January 8, 2008

TO: David Parisi, Columbia River Crossing Project Team
FROM: CRC Pedestrian and Bicycle Advisory Committee (PBAC)
SUBJECT: Pedestrian and Bicycle Advisory Committee Status Report and Initial Recommendations on Bridge Alternatives

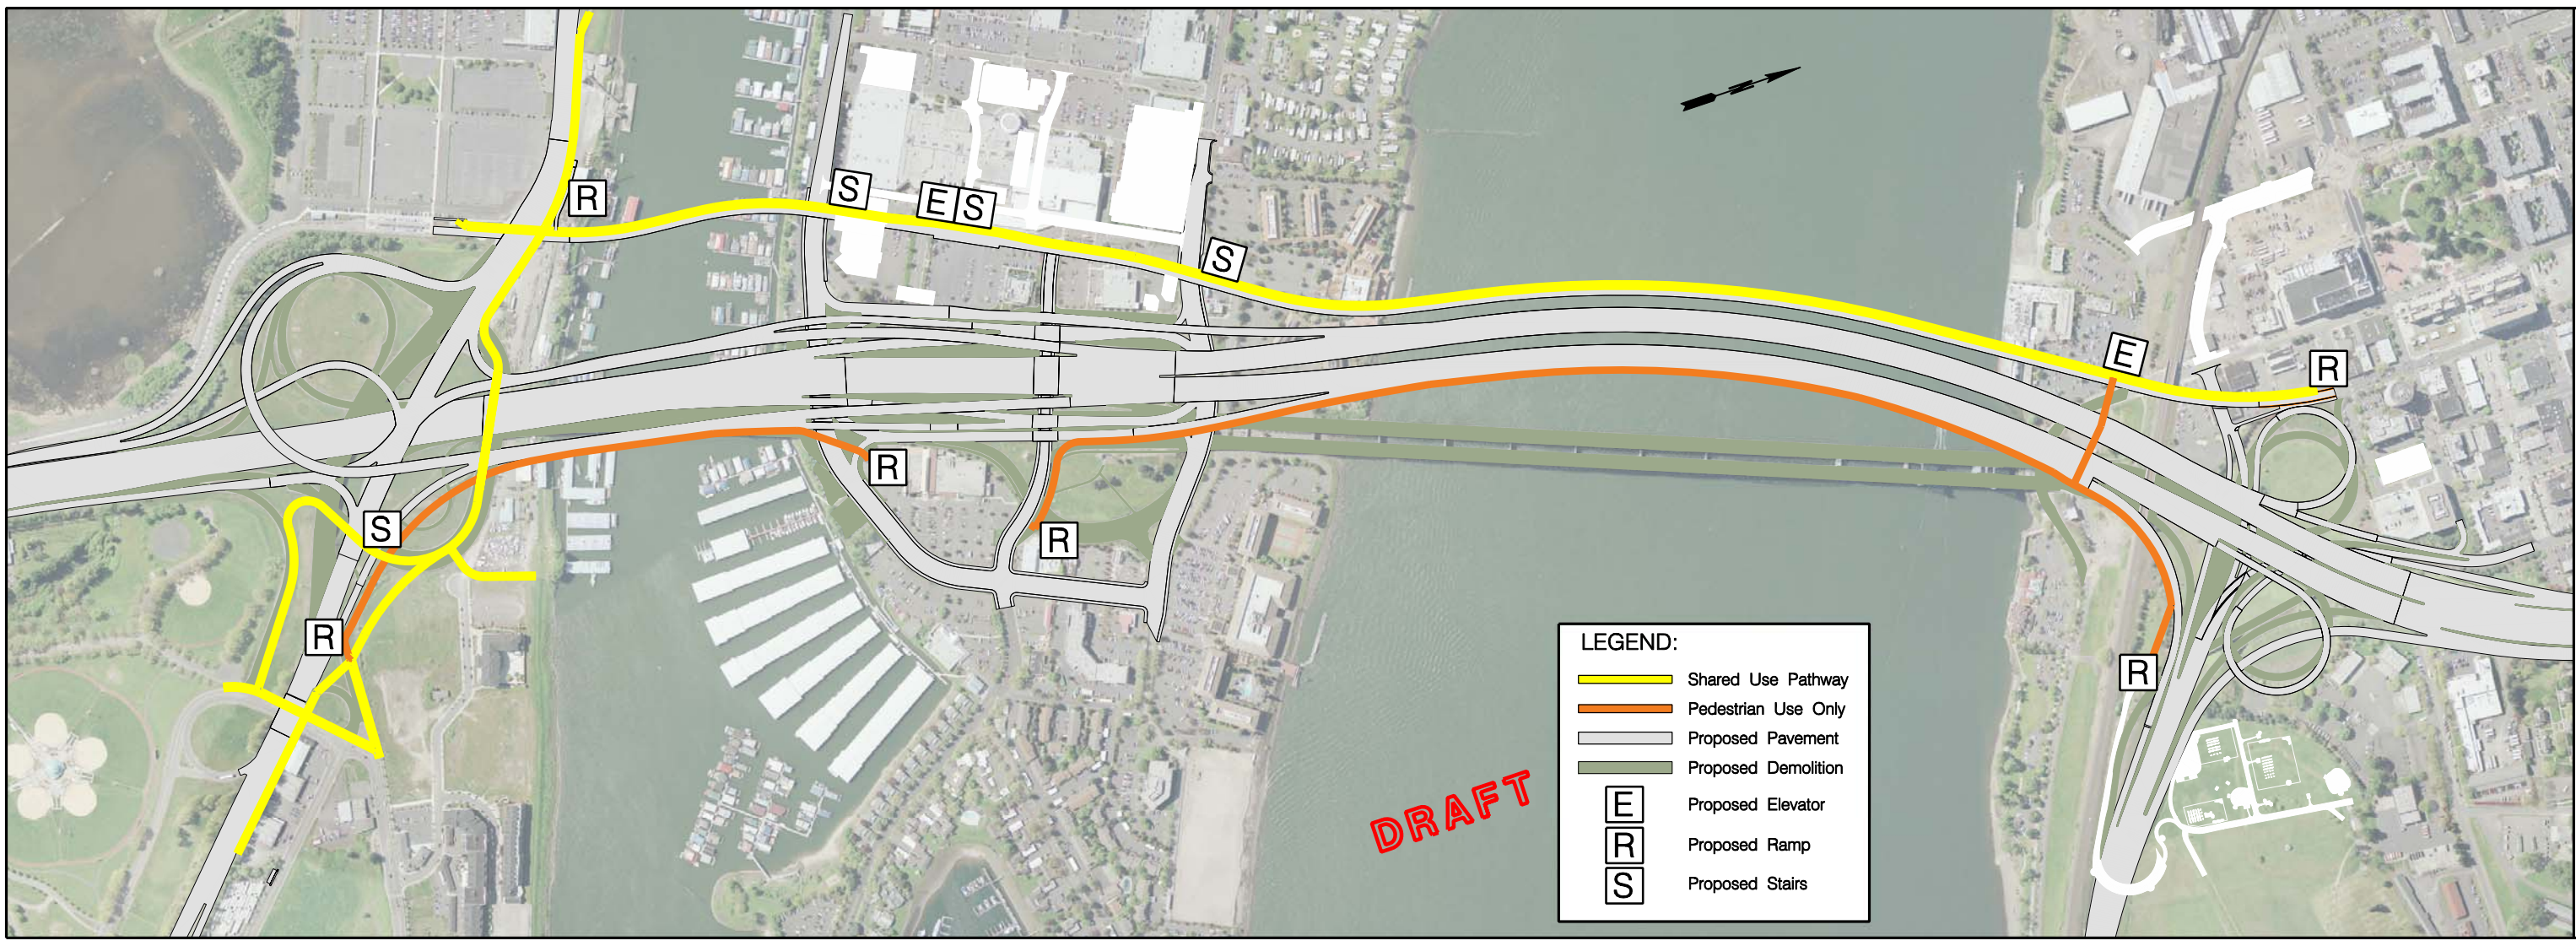
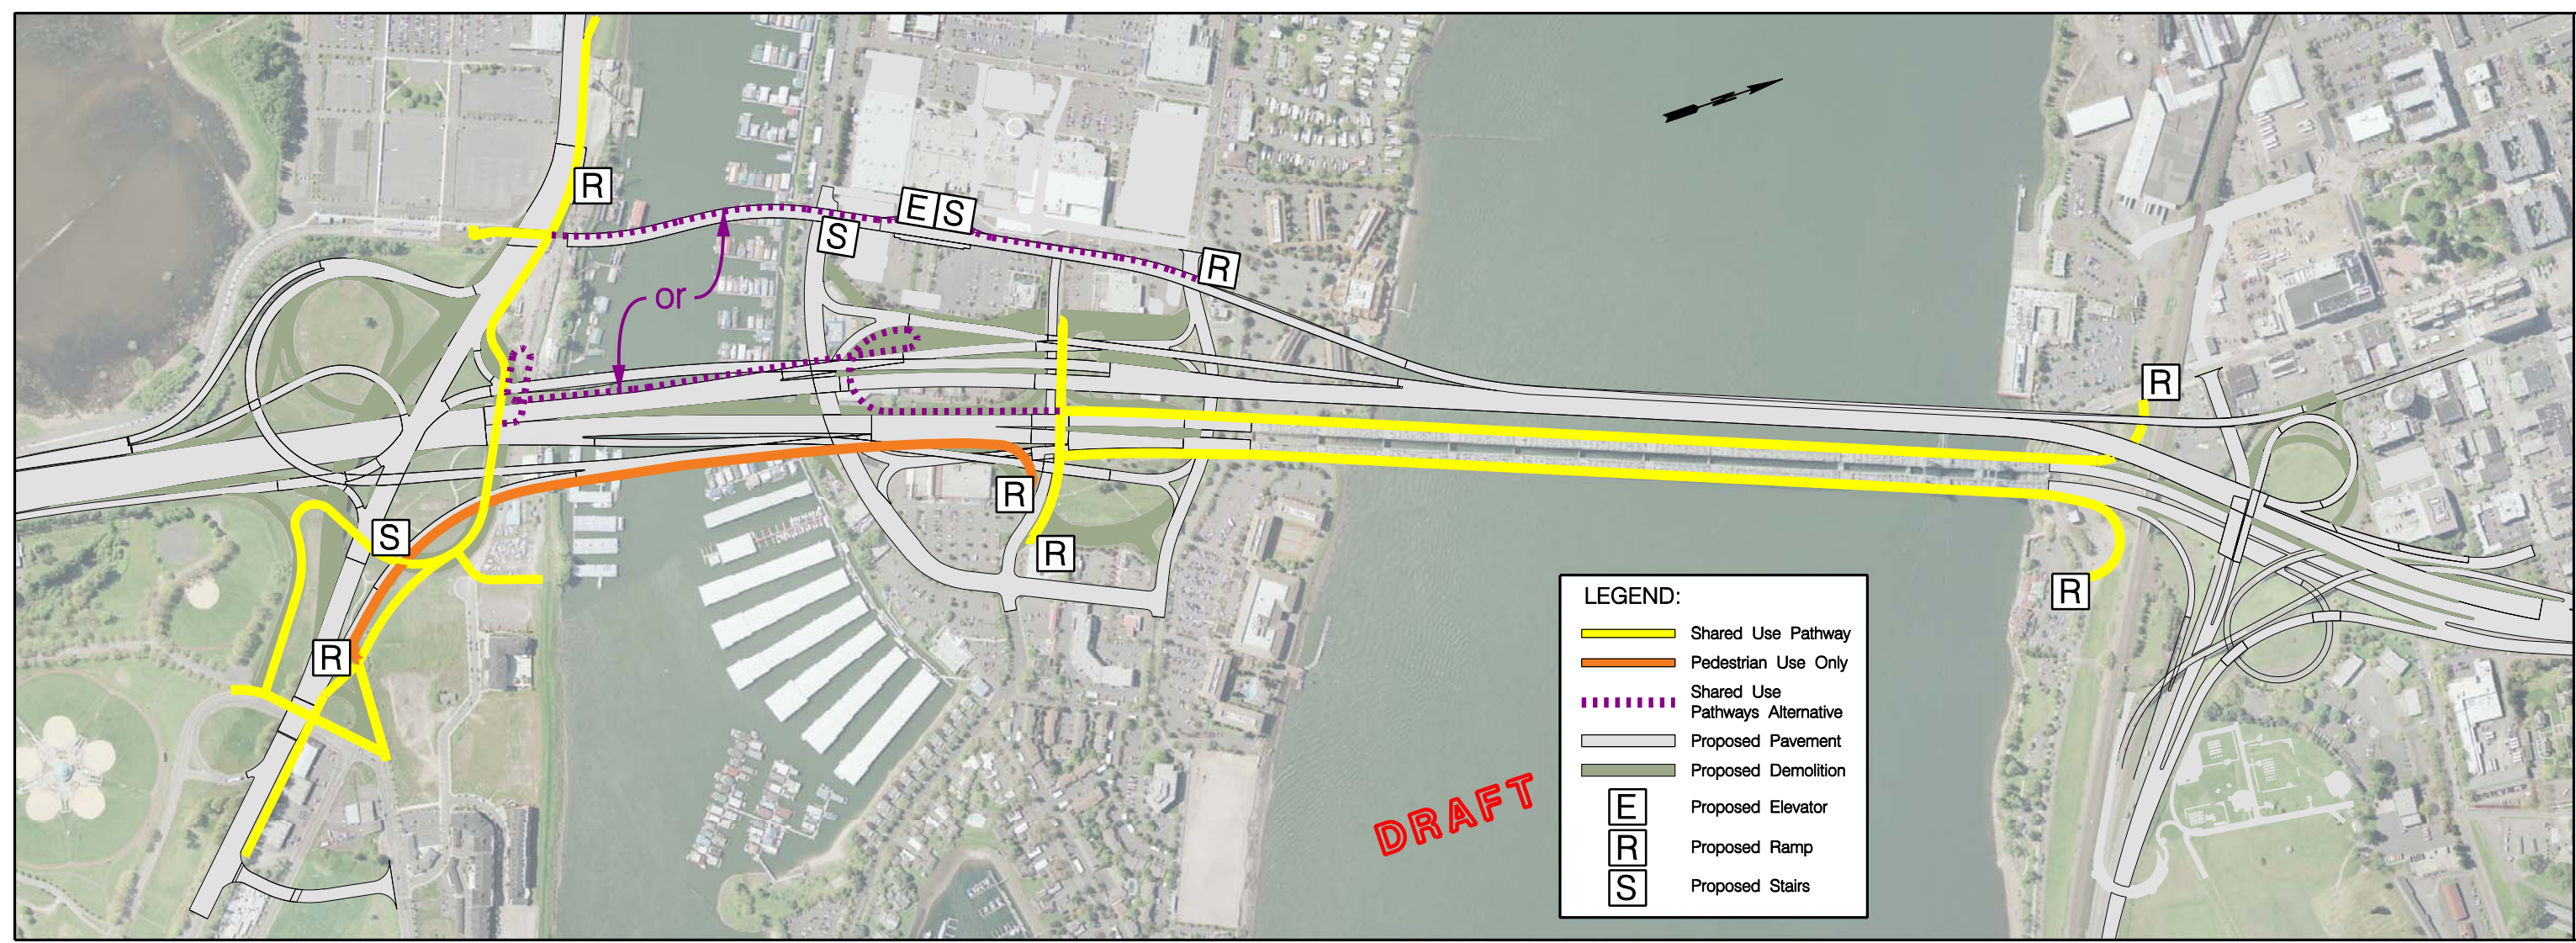
The PBAC has developed recommendations for pedestrian and bicycle facilities based upon preliminary plans for both the Replacement and Supplemental bridge alternatives. These recommendations are summarized in the attached maps. Two maps are provided, one for the Replacement bridge option and the second for the Supplemental bridge alternative. The recommendations relate to the following set of features: shared-use pathways, pedestrian-only paths, pathway access points and connections to existing facilities, and the potential locations of elevators, stairs and ramps.
